QUALITY ASSURANCE -- NON-CONFORMANCE REPORT

Location: Changxing Island, Shanghai, P.R. China **Report No:** NCR-000522
Prime Contractor: American Bridge/Fluor Enterprises, a JV **Date:** 28-Nov-2009
Submitting Contractor: Zhenhua Port Machinery Company, Ltd (ZPMC), Changxing Island **NCR #:** ZPMC-0495

Job Name: SAS Superstructure

Subject: NCR No. ZPMC-0495

WELD NUMBER: FB204-032-069

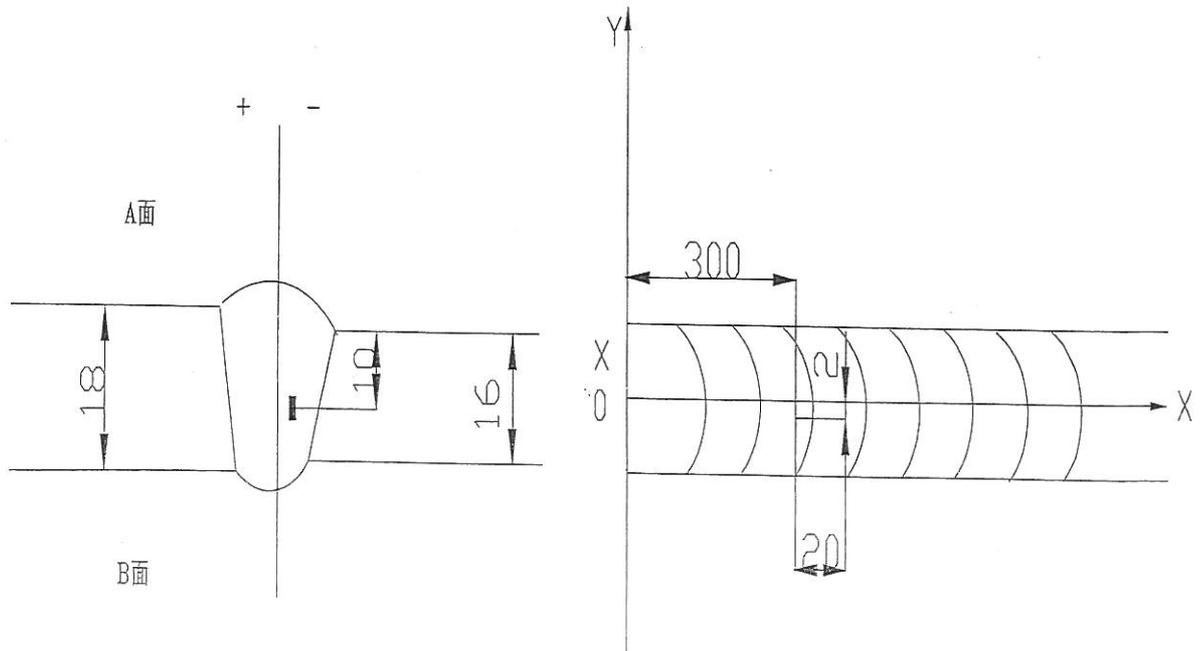
Rejected indication found by ultrasonic inspection is less than the maximum allowance aggregate length.

(UT探伤发现的缺陷总长度小于最大允许长度。) FB204-032-069

1. Did not clear the weld pass completely in time.

1. Gouge or grind from nearer side from metal edge ($D \leq 0.65T$, "D" is depth of defects, "T" is thickness of metal) to remove all defects;

2. Follow repair WPS for joint preparation, preheat, and weld deposit;

3. Verify with VT no defects remain in the weld joint prior to welding;

4. Grind the repaired area flush with base metal or the adjacent weld;

5. Perform UT inspection to the weld along with 50mm on each end of the repair area;
